WLTP

Comparison of WLTP unified database distributions and WLTC rev2 distributions

Heinz Steven

08.10.2011

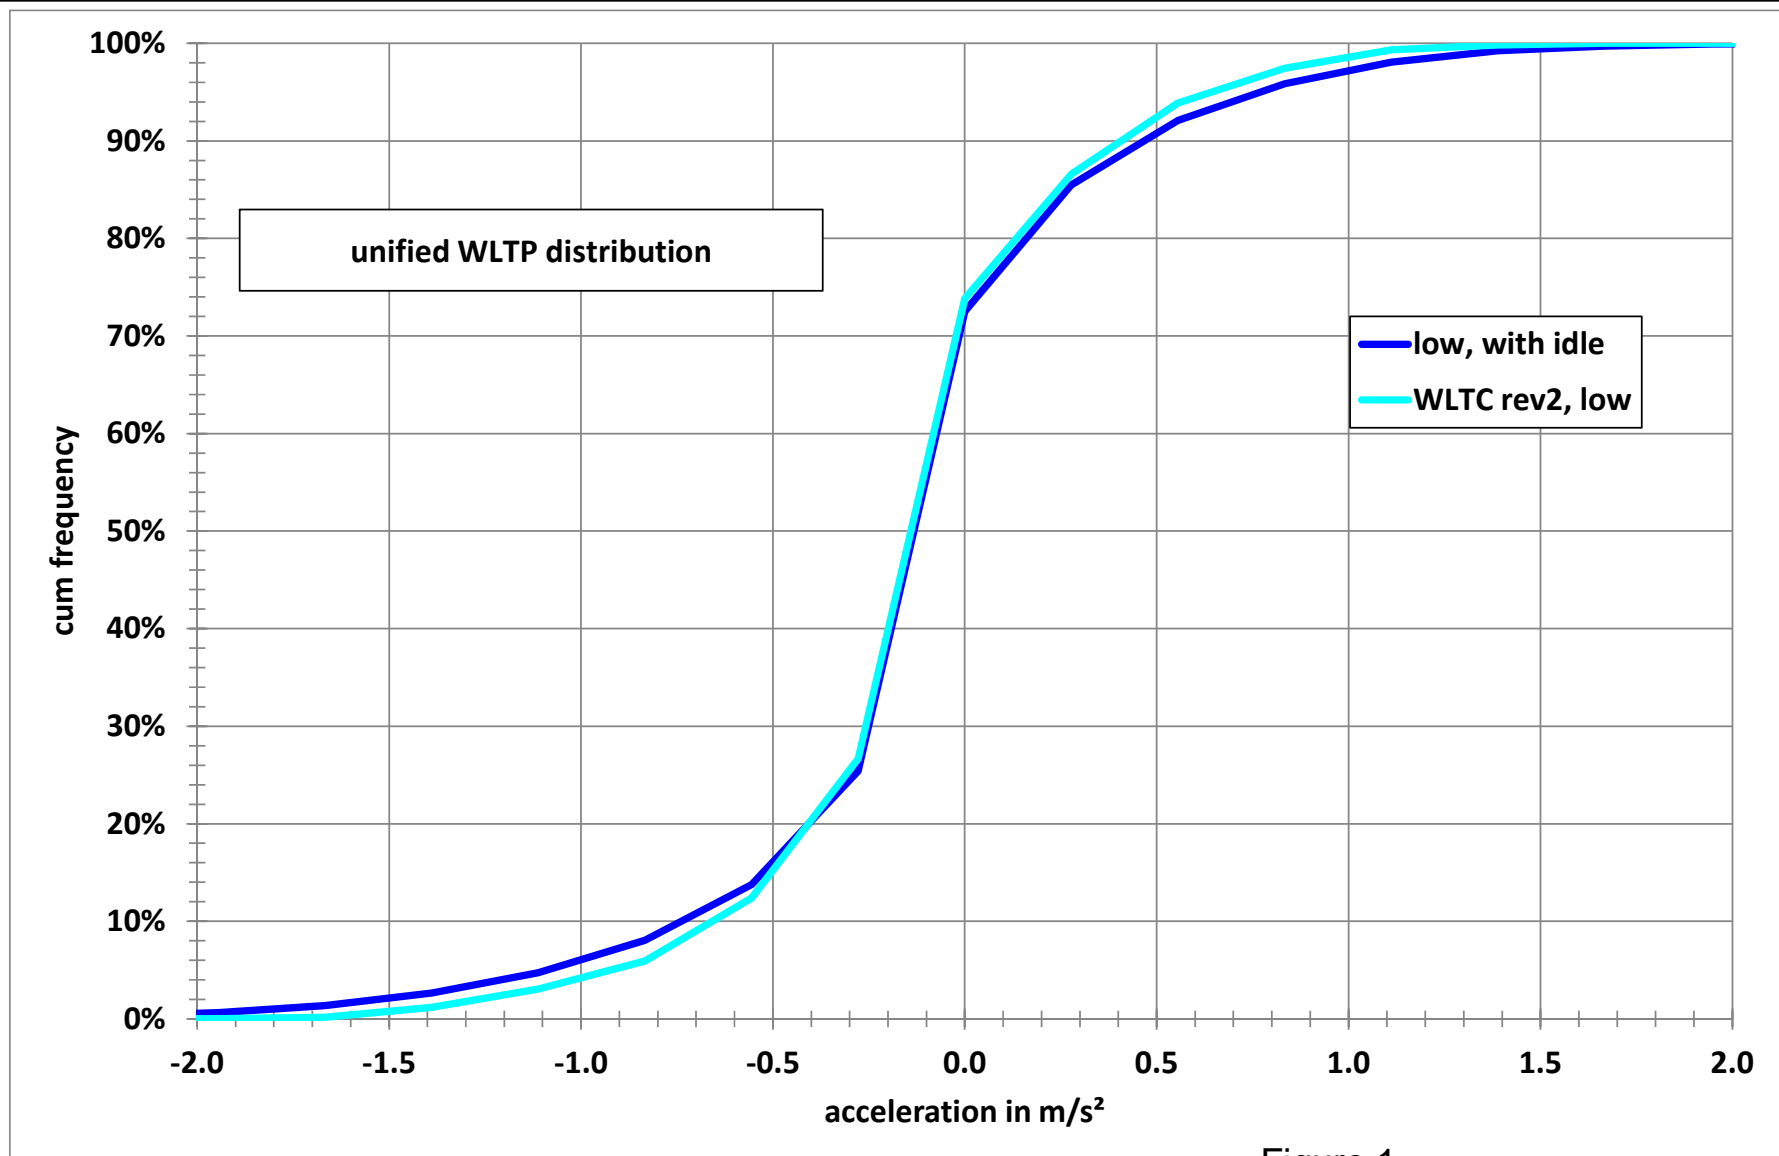
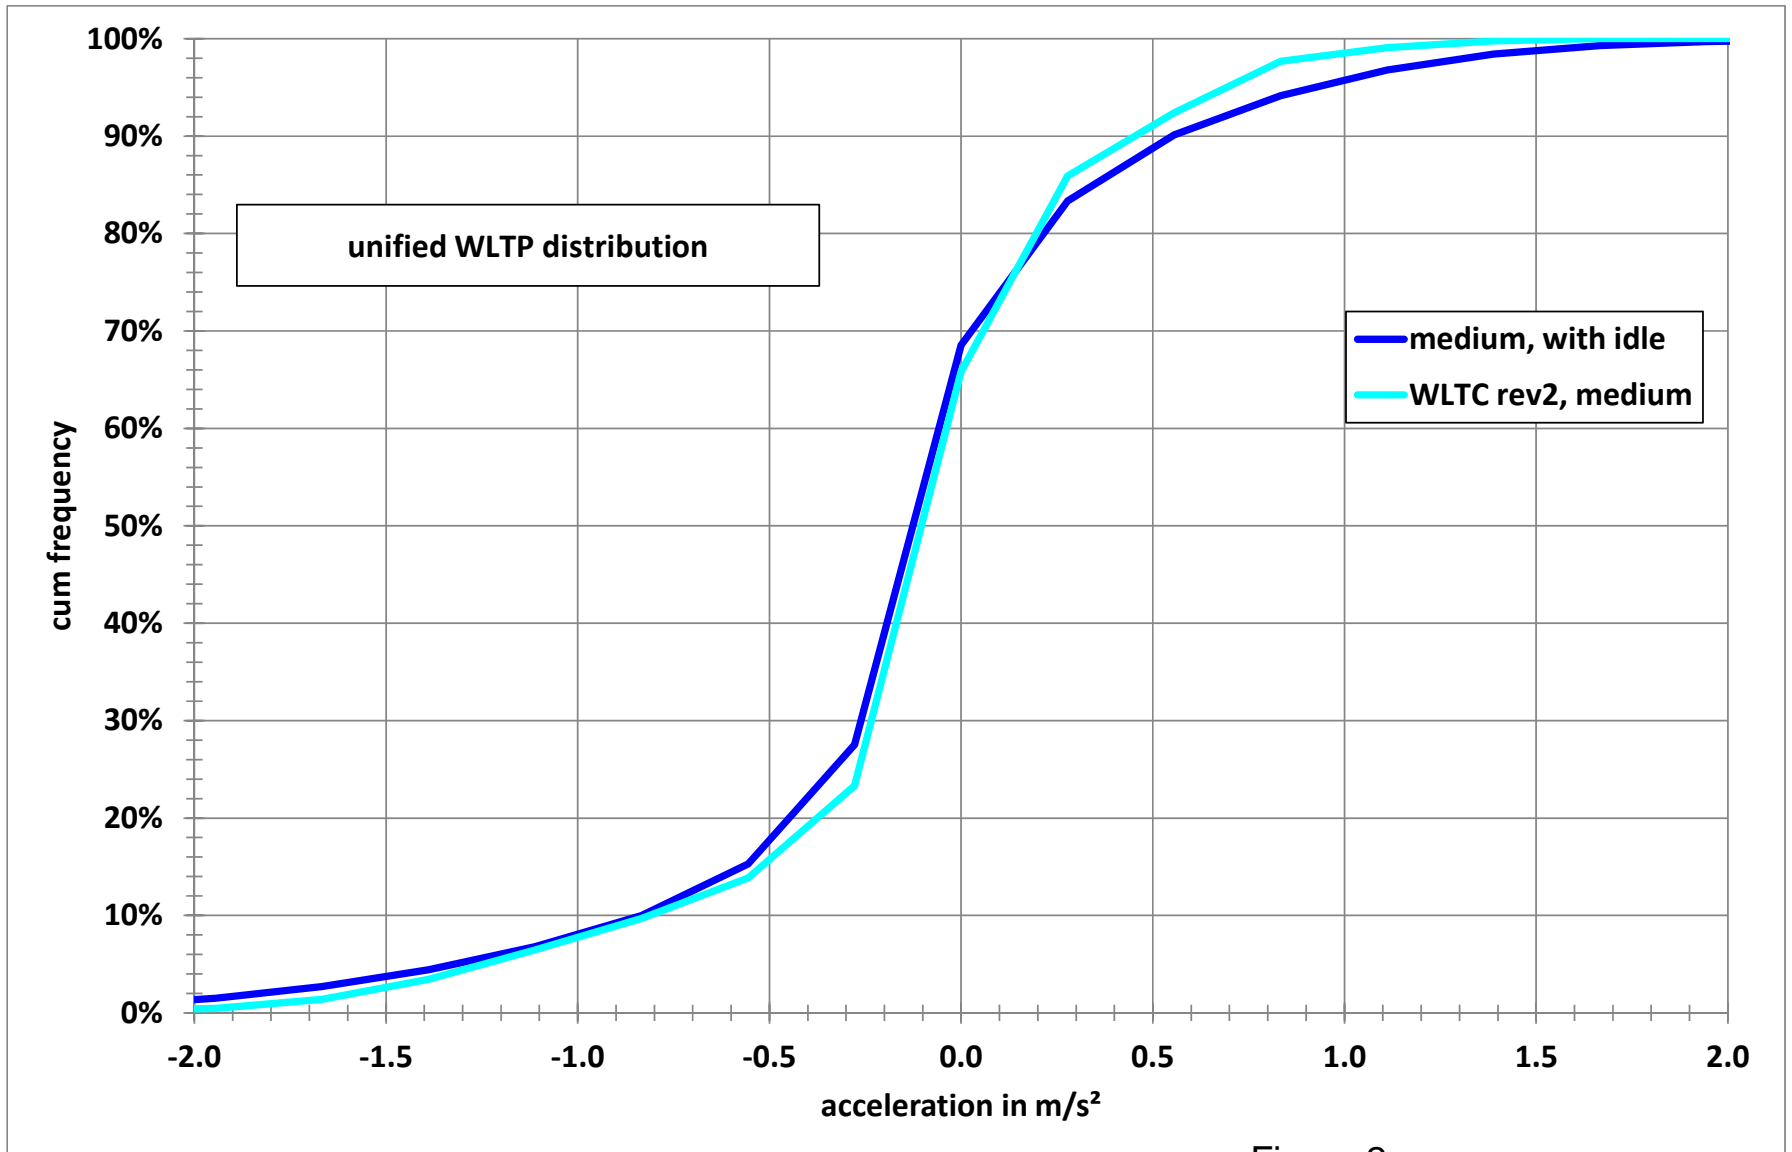
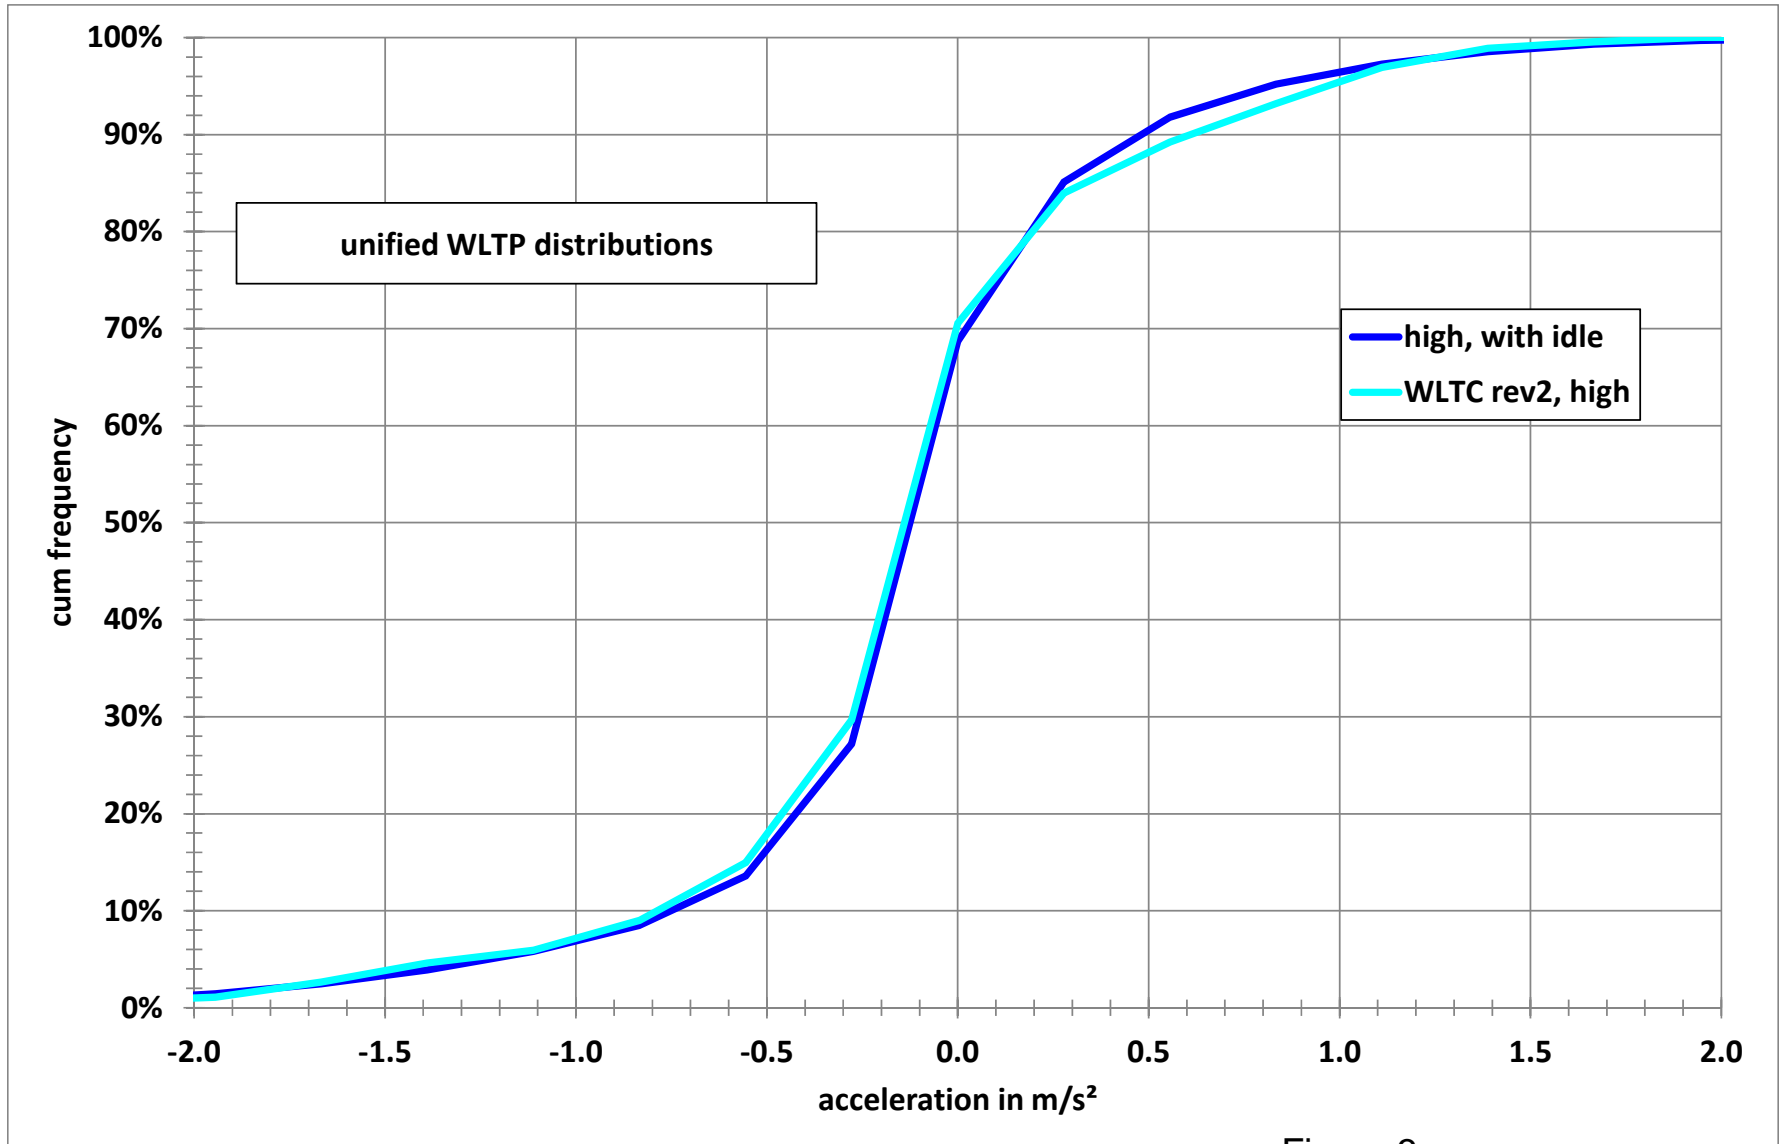
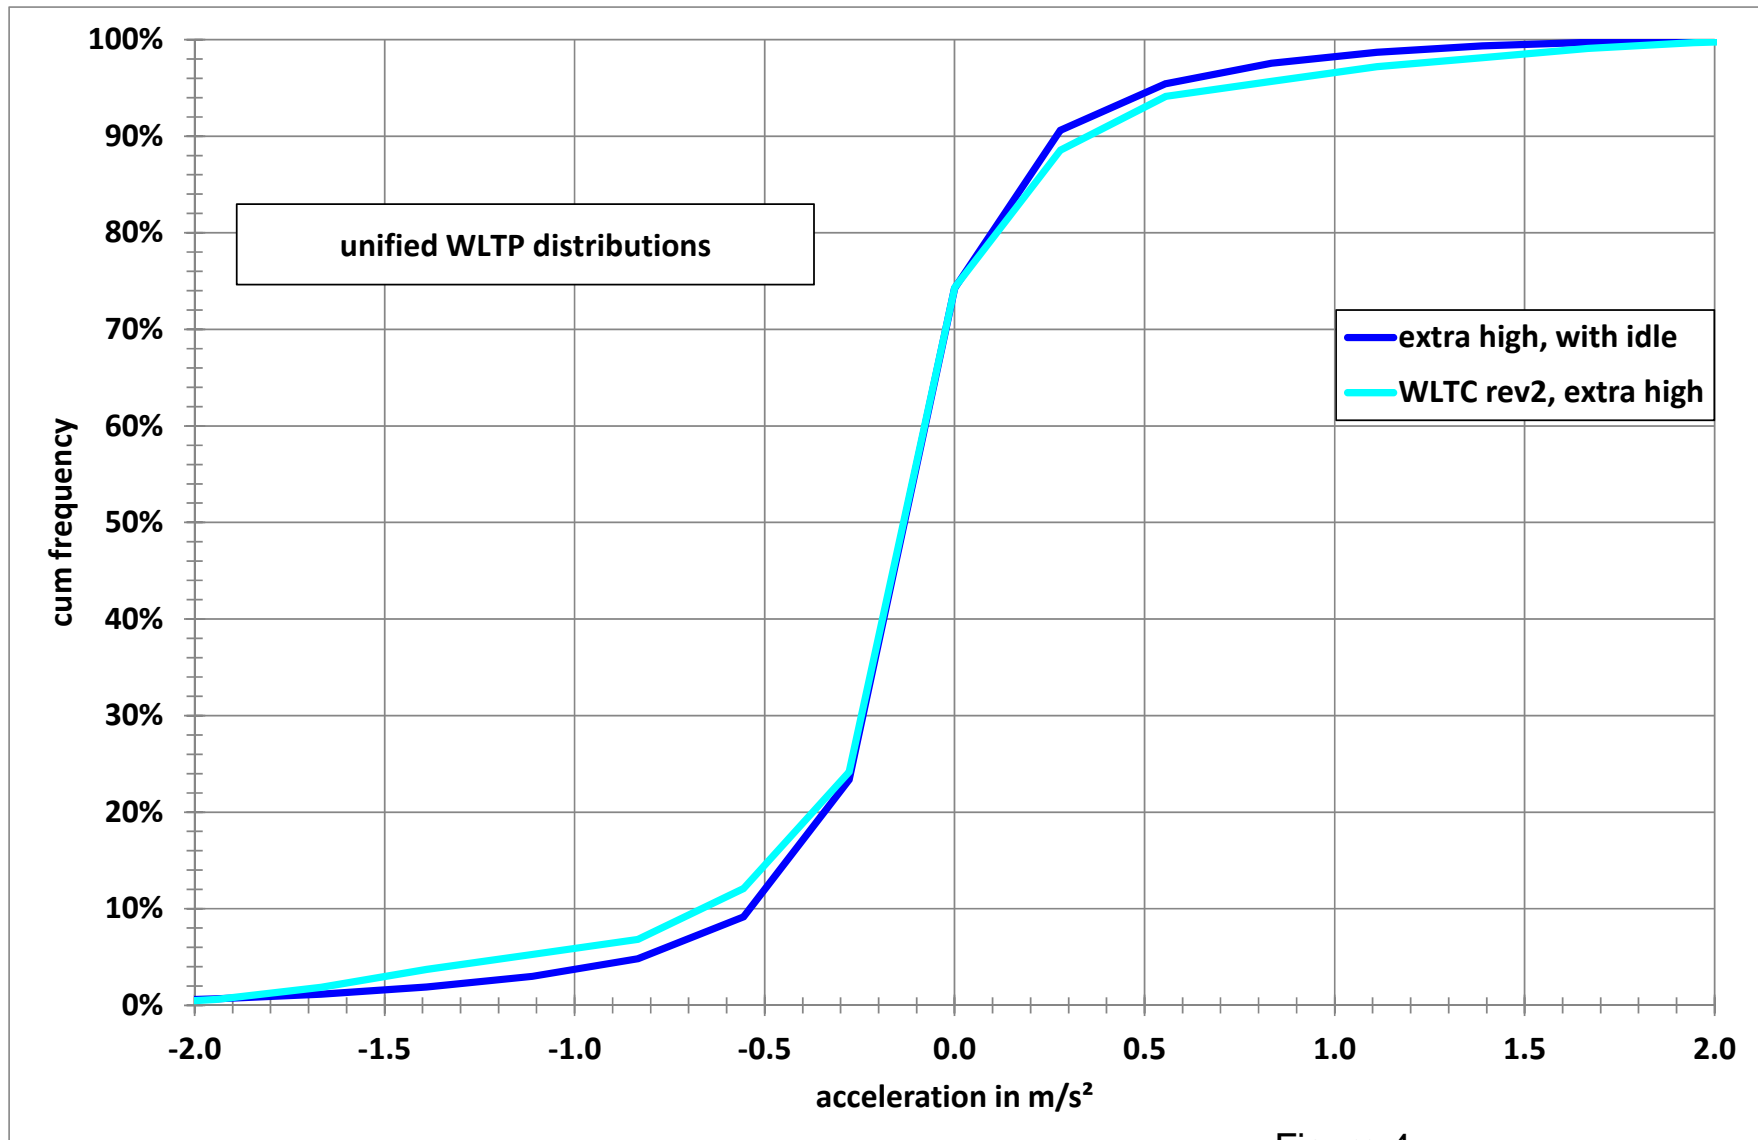
- Only 30% of the operation time or even less is related to positive accelerations.
- Where is the justification to include the idling phases in the distributions and the least square calculation?
- The WLTC rev2 distributions for the low and the medium speed parts show lower dynamics in the positive acceleration sections than the database distributions.
- For the high and extra high speed parts it is the opposite, but less pronounced.
- Deviations to lower dynamics have the same influence on the least square sum as deviations of the same order to higher dynamics.
- This led to the differences shown in the comparison.

Figure 5

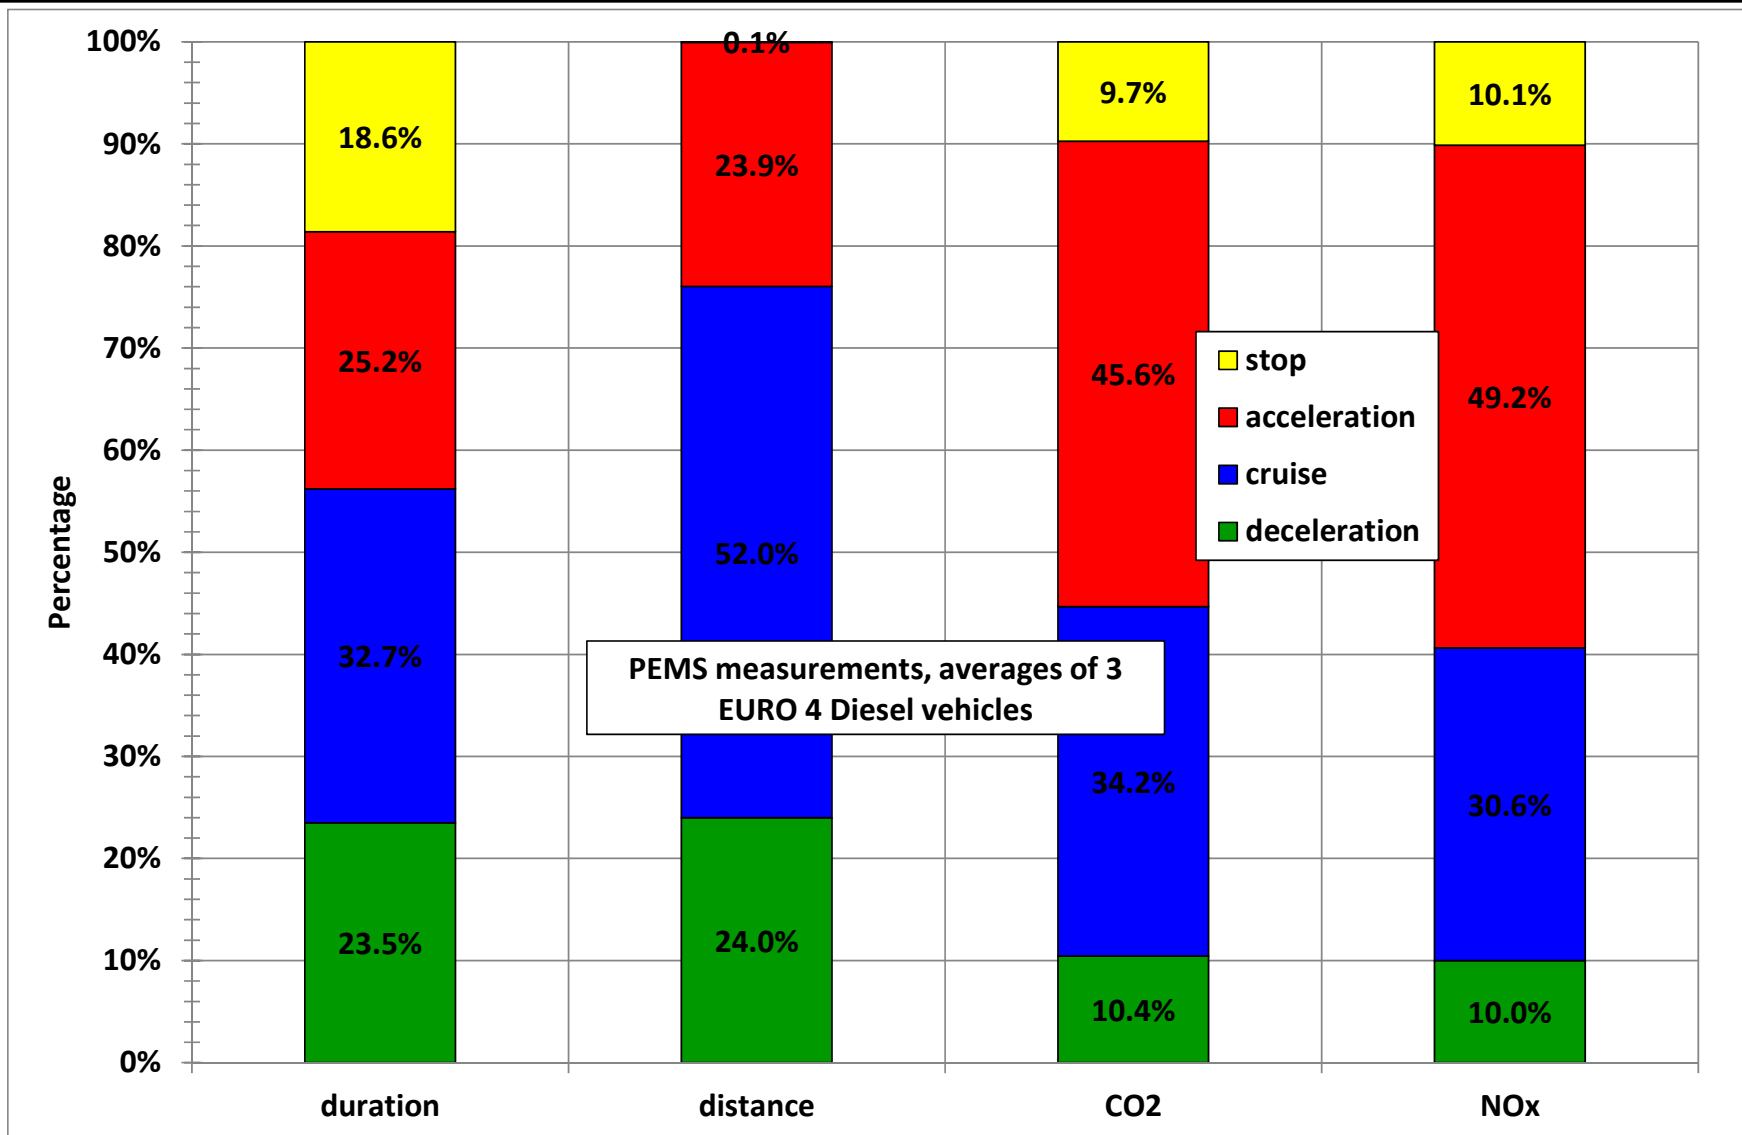
- This situation is unsatisfactory, especially because the acceleration phases determine the major parts of the CO₂ and NO_x emissions in real traffic.
- Figure 5 shows results of PEMS measurements performed with 3 different EURO 4 Diesel vehicles in Stuttgart within a project sponsored by LUBW.
- The routes driven were related to the low speed part. The idling and deceleration phases determine about 10% of CO₂ and NO_x emissions each, the by far most important phase is the acceleration phase.
- In this context, the situation will not be improved enough, if the idling phases are disregarded for the analysis (see figures 6 and 7).
